BCC DS
RECEIVED
20/10/2026
APPLICATION REF
A007097295

OUR REF: J26-00039
DATE: 20/10/2026

RE: RESPONSE TO INFORMATION REQUEST NOTICE – APPLICATION FOR RECONFIGURING A LOT (DEVELOPMENT PERMIT) – BOUNDARY REALIGNMENT 2 LOTS INTO 2 LOTS – LAND AT 14 GILLAN STREET NORMAN PARK QLD 4170, DESCRIBED AS LOT 2 ON RP12575 AND LOT 51 ON RP12574.

Amended Proposal Plan, Prepared by Gilvear Planning Pty Ltd

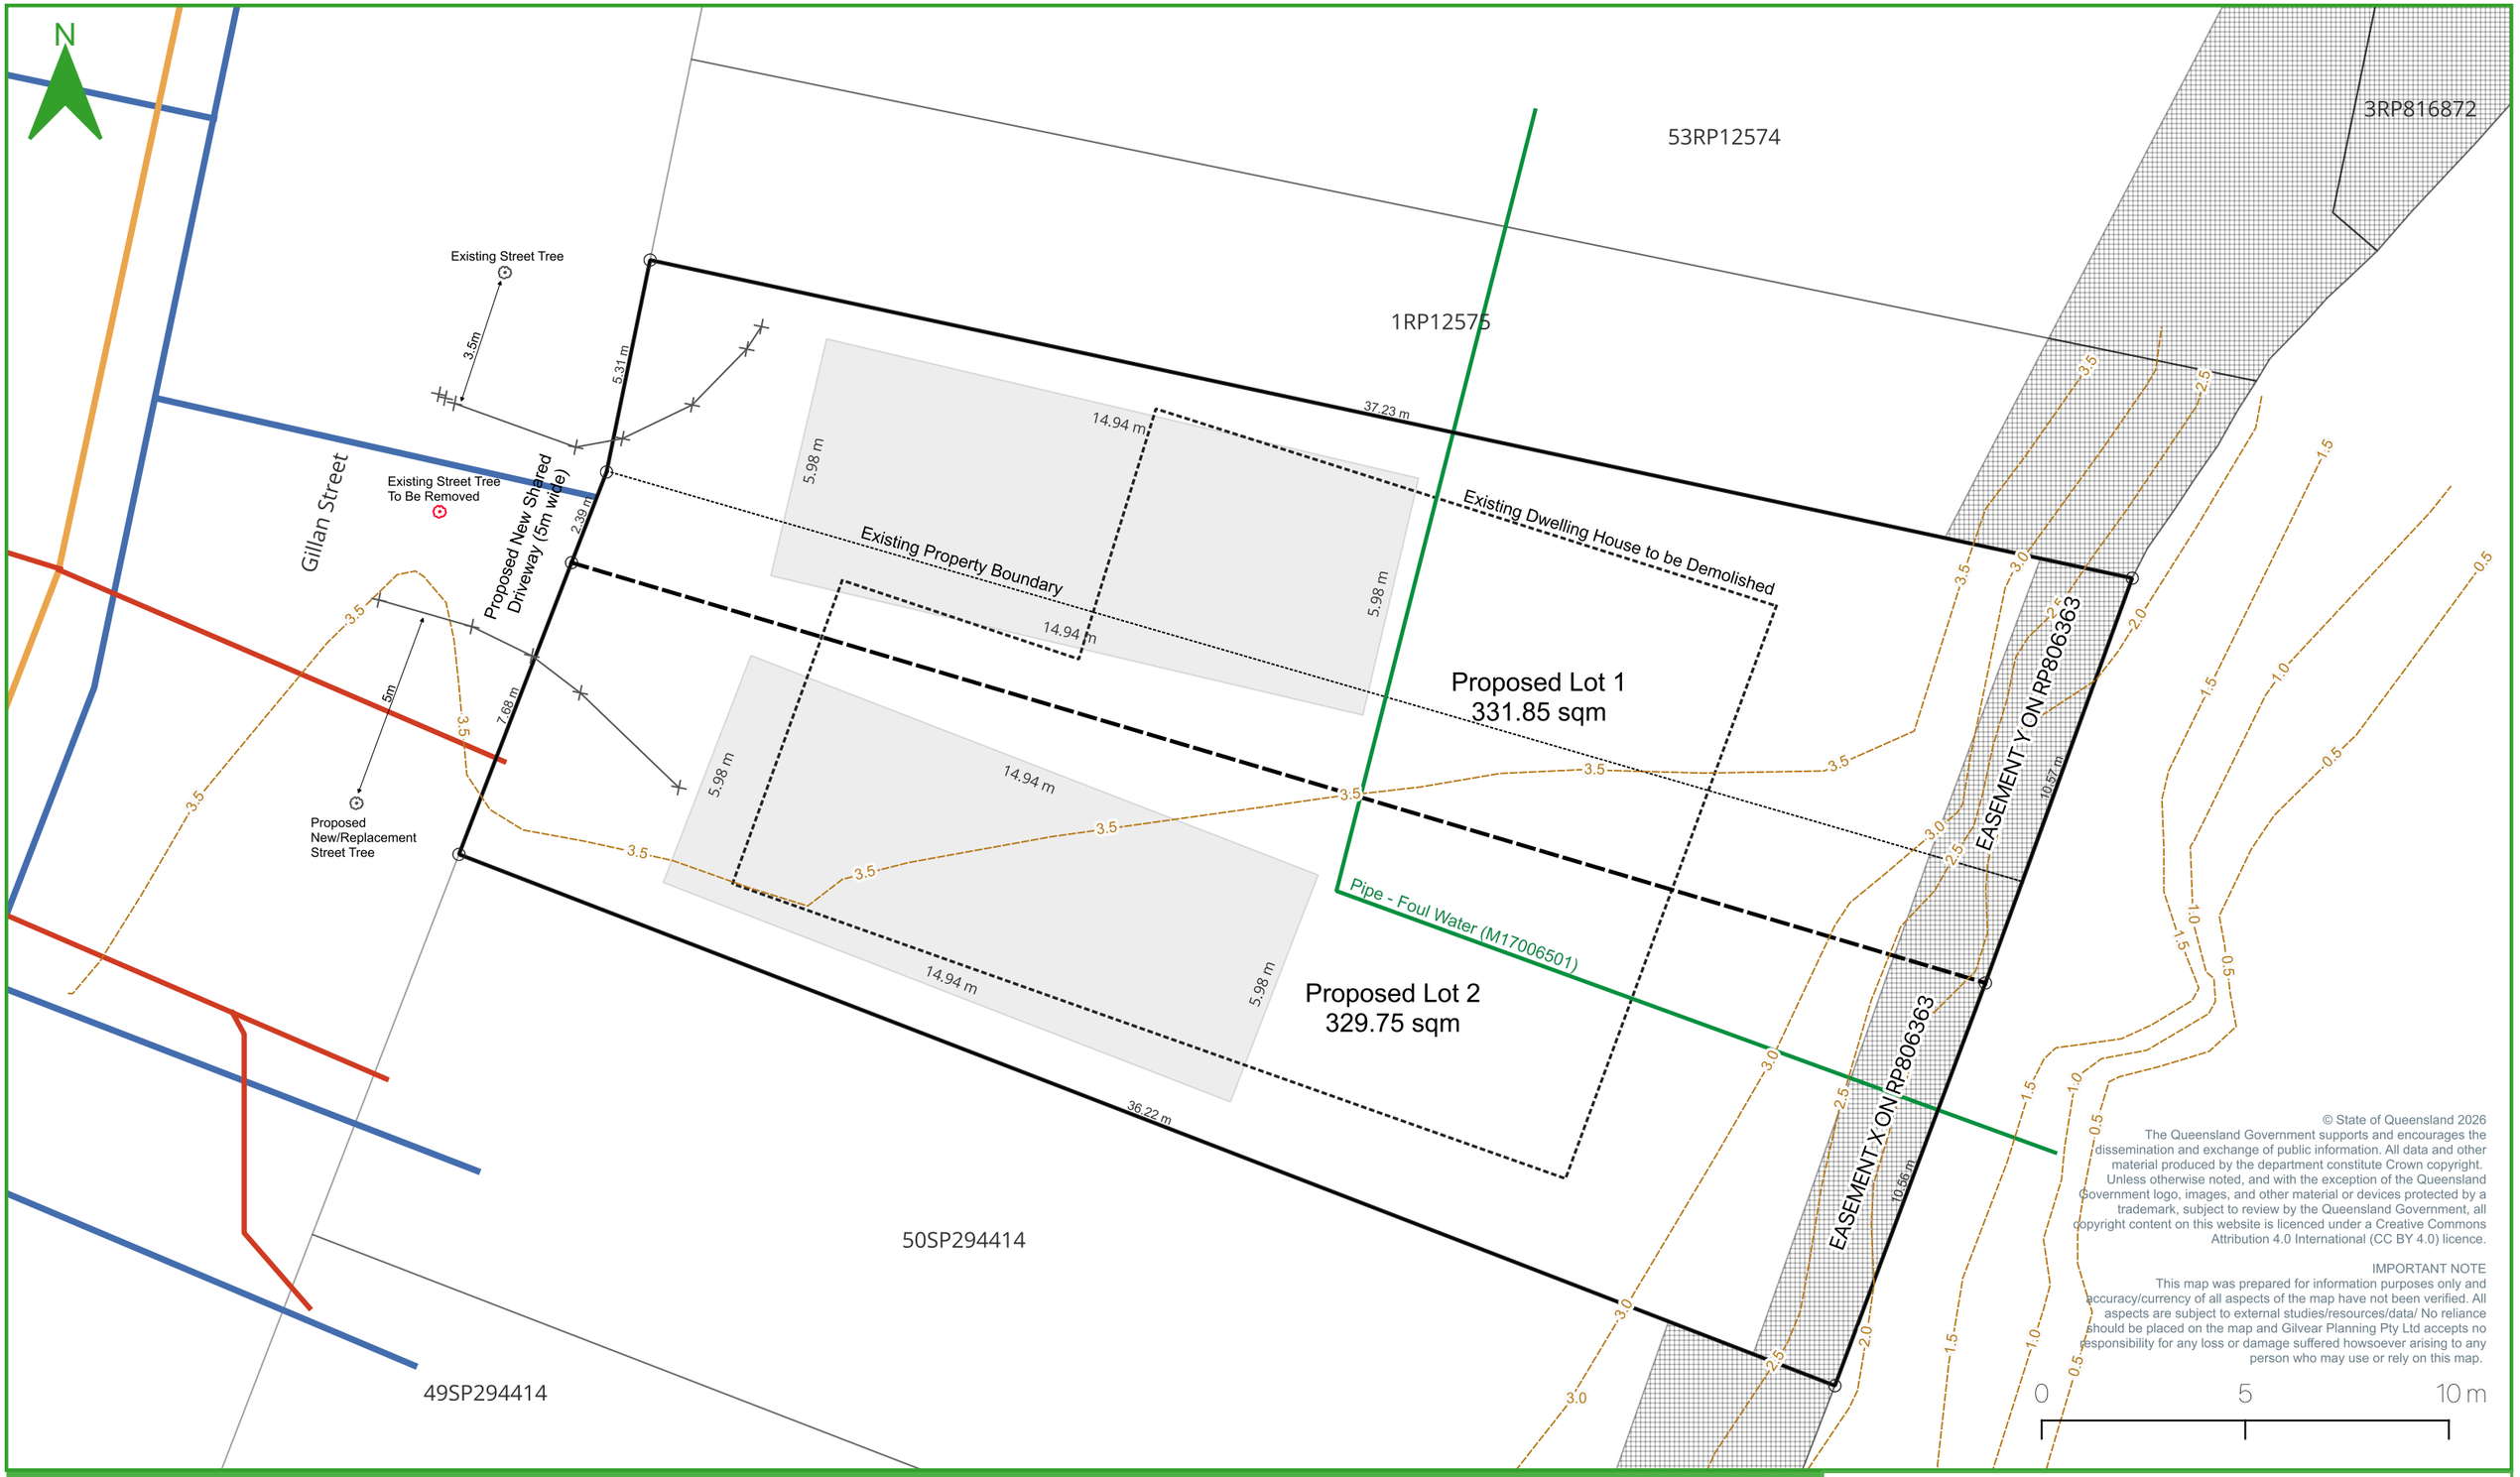
The proposal results in the creation of two lots with frontages of less than 10m. Subsequently, a shared access arrangement is required to be provided that is located centrally along the common property boundary of the proposed lots, in accordance with PO27/AO27.4 of the Subdivision code. Furthermore, it is Council's preference to retain the existing street trees at the Gillan Street frontage, where possible. Noting the request for a shared access, it is suggested that the northern-most street tree is retained and the centrally located street tree is removed and replaced at an appropriate location along the frontage.

a) *Provide amended subdivision plans showing a shared access arrangement between the proposed lots that enables the retention of street trees where possible and demonstrating compliance with PO27/AO27.4 of the Subdivision code.*

An updated proposal plan (prepared by Gilvear Planning Pty Ltd) is provided at Attachment 1. Proposed plan amendments have been summarised below:

- Inclusion of a new shared access driveway (approximately 5m wide).
- Proposed removal of an existing street tree (as depicted in red on the updated proposal plan).
- Proposed location of a new/replacement street tree (south of the shared access driveway)
- Appropriate separation distances between street trees (existing and/or new/replacement) – approximately 3.5m to 5m from the proposed shared access driveway.

The proposed shared access driveway is a suitable option in this instance and ensures compliance with Acceptable Outcome AO27.4 of the Subdivision Code. Impacts on existing street trees are considered to be minimal, given there is sufficient area for a new/replacement street tree to be established. The proposal is unlikely to impact on on-street car parking provisions. The proposed shared access driveway will help to retain existing on-street car parking provisions.

Concept Stormwater Drainage Layout Plan, Prepared by Rogers Consulting Services Pty Ltd

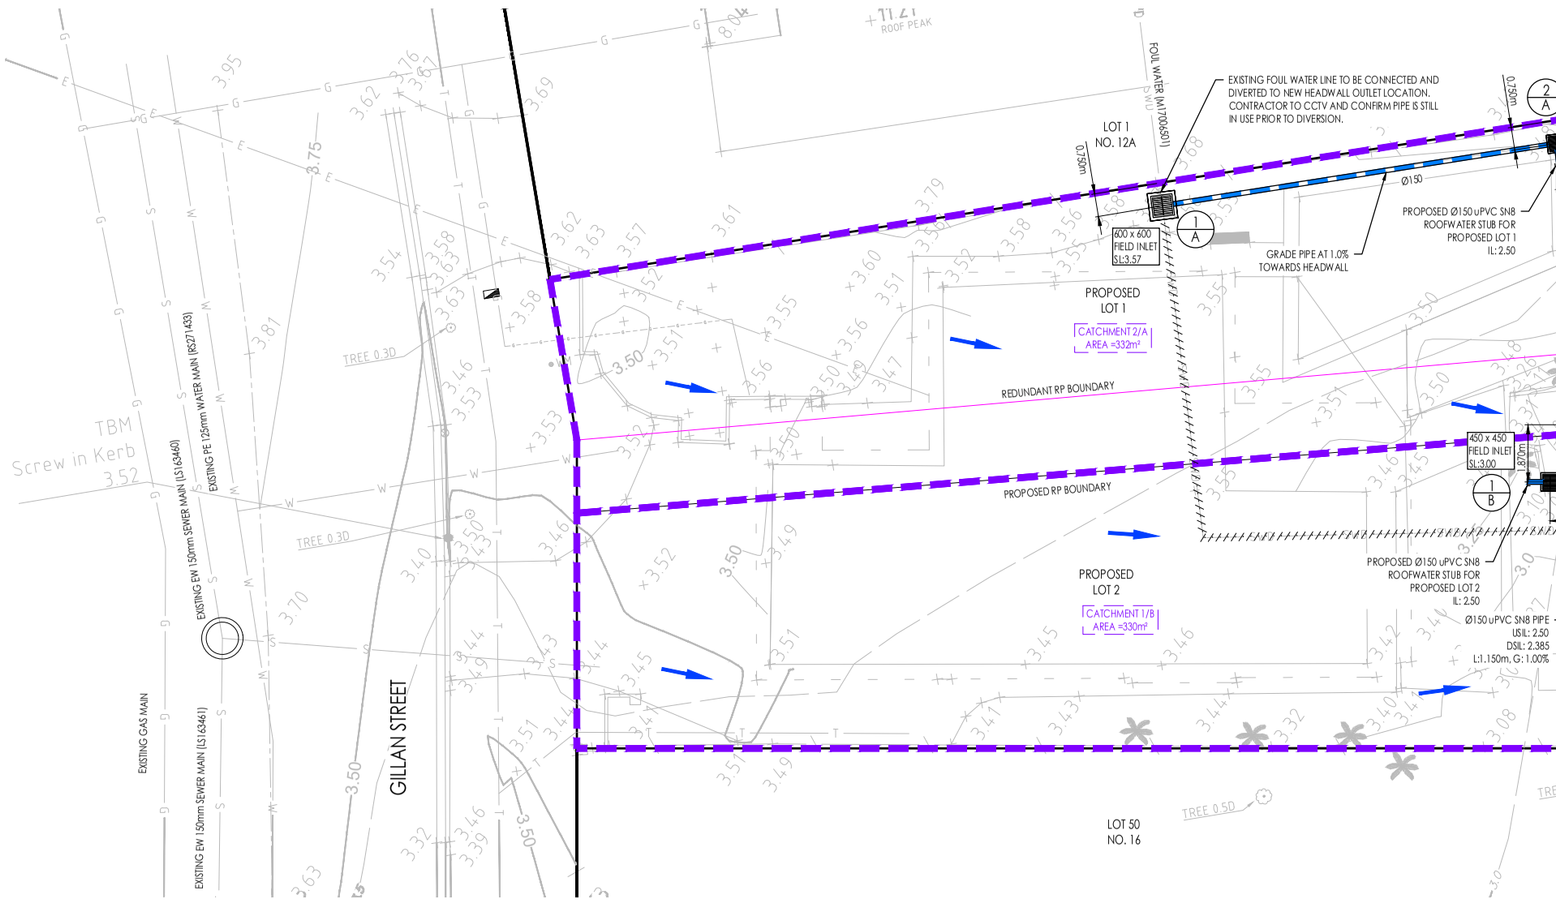
An existing foul water pipe servicing an upstream property traverses the site to the rear and is proposed to be removed as part of the future servicing arrangement. Insufficient information has been provided to demonstrate that the upstream property will be serviced following removal of the pipe.

a) *Provide detailed design to demonstrate the provision of an appropriate upstream connection and continuity of service to affected upstream properties.*

A Concept Stormwater Drainage Layout Plan, prepared by Rogers Consulting Services Pty Ltd, is provided at Attachment 2. Specifically, we note the concept plan provides details on a new upstream connection to the existing foul water pipe (adjacent to the northern boundary of proposed Lot 1). The proposed new connection will ensure continuity of service to/for affected upstream properties.
